**ADDENDUM NO. 1
NEW ELEVATOR
AT MURPHY ELEMENTARY SCHOOL
ROUND LAKE SCHOOL DISTRICT NO. 116
PROJECT NO. 23170**

Board of Education
Round Lake School District 116
884 West Nippersink Road
Round Lake, Illinois 60073

1 FOUNDATION PLAN
1/4" = 1'-0"

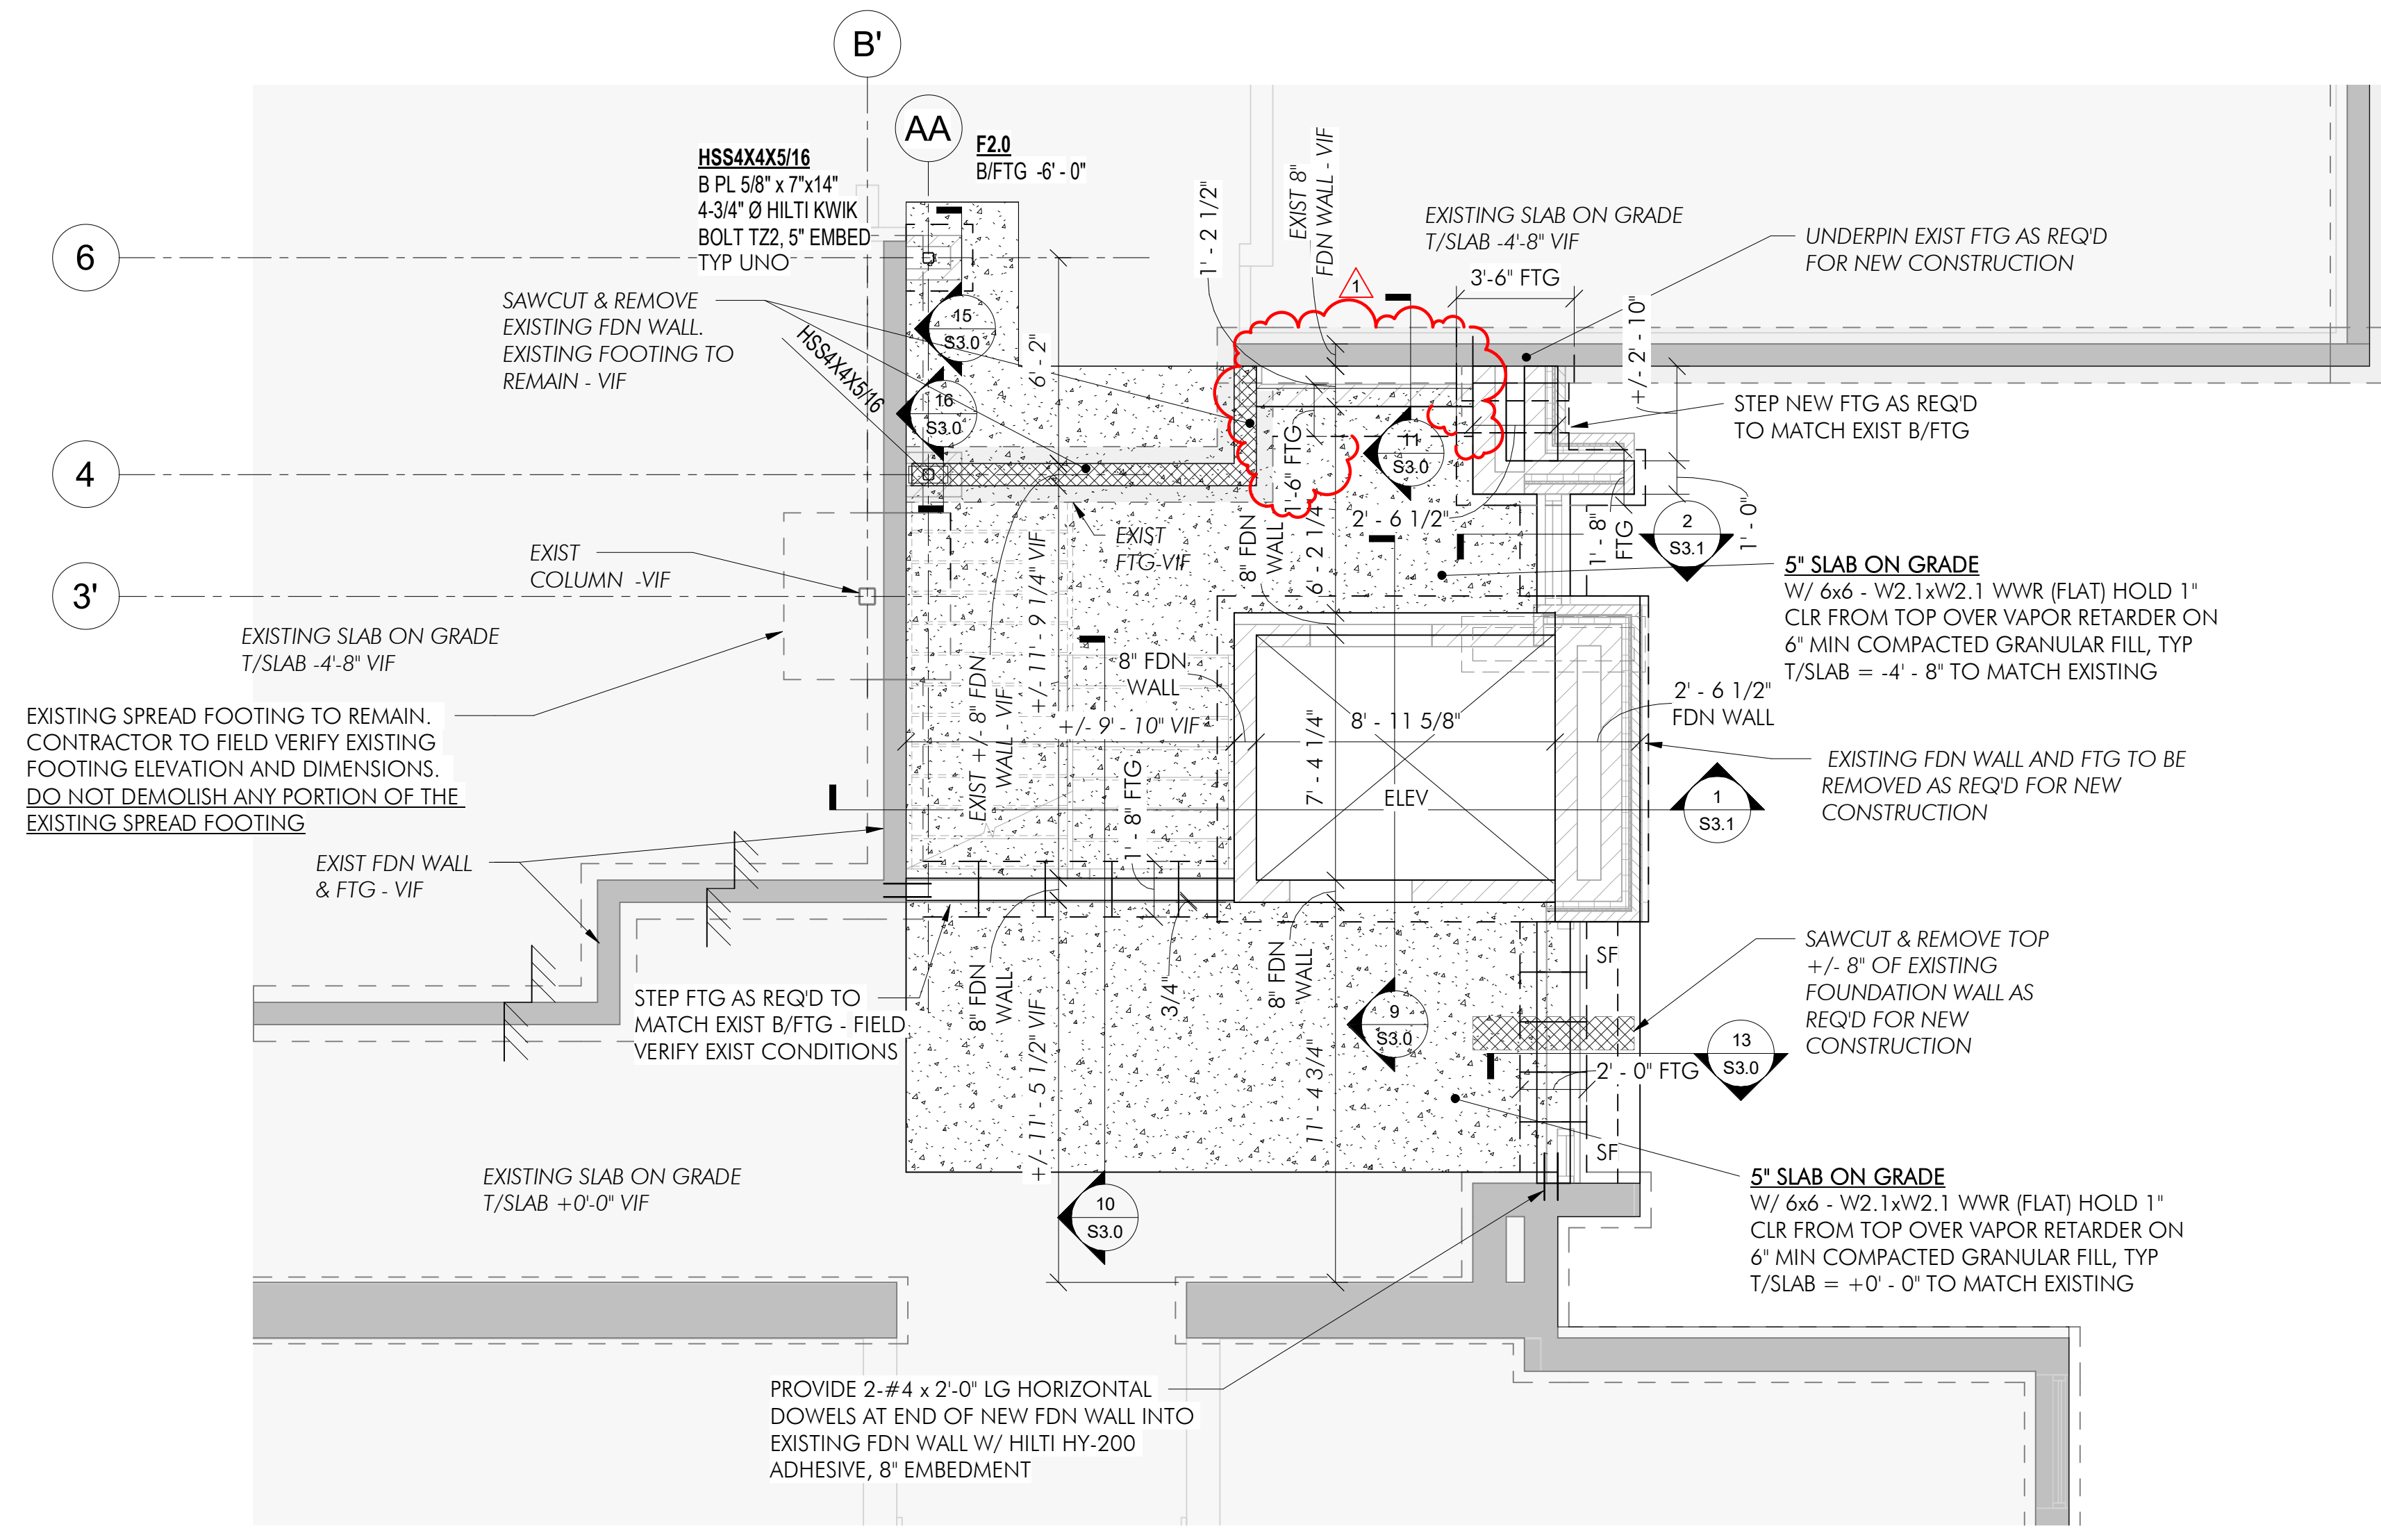
ITEM NO. 4: DRAWINGS, SHEET S1.1, PARTIAL FOUNDATION PLAN, SECOND FLOOR & ROOF FRAMING PLANS

1. Revise Foundation and Framing Plans 1, 2 & 3/S1.1 as shown on attached Sheet S1.1.

11 SECTION
3/4" = 1'-0"

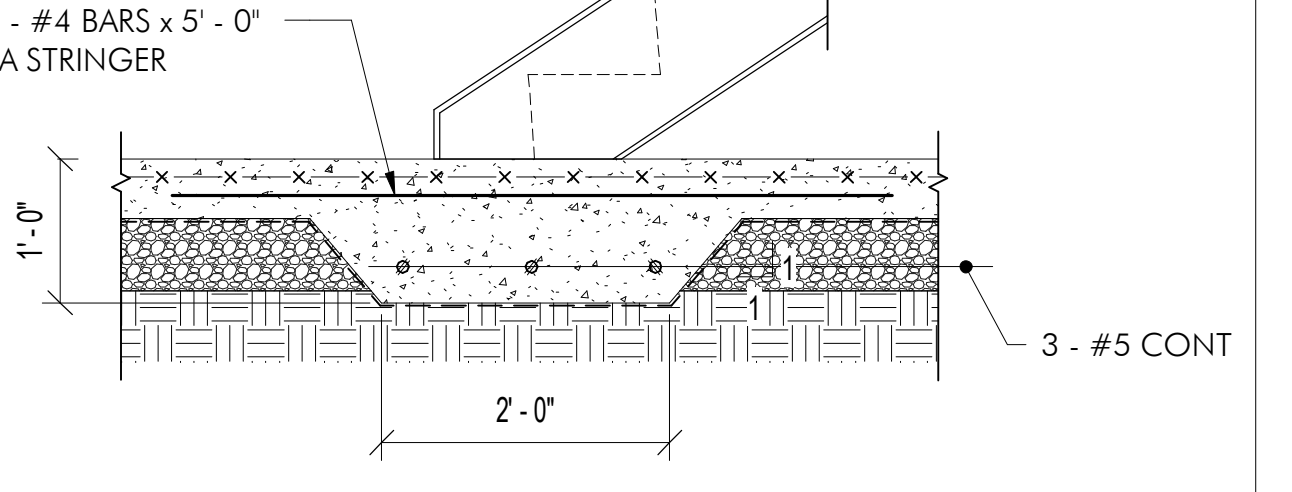
ITEM NO. 5: DRAWINGS, SHEET S3.0, FOUNDATION DETAILS

1. REVISE detail 11/S3.0 as shown on attached Sheet S3.0.
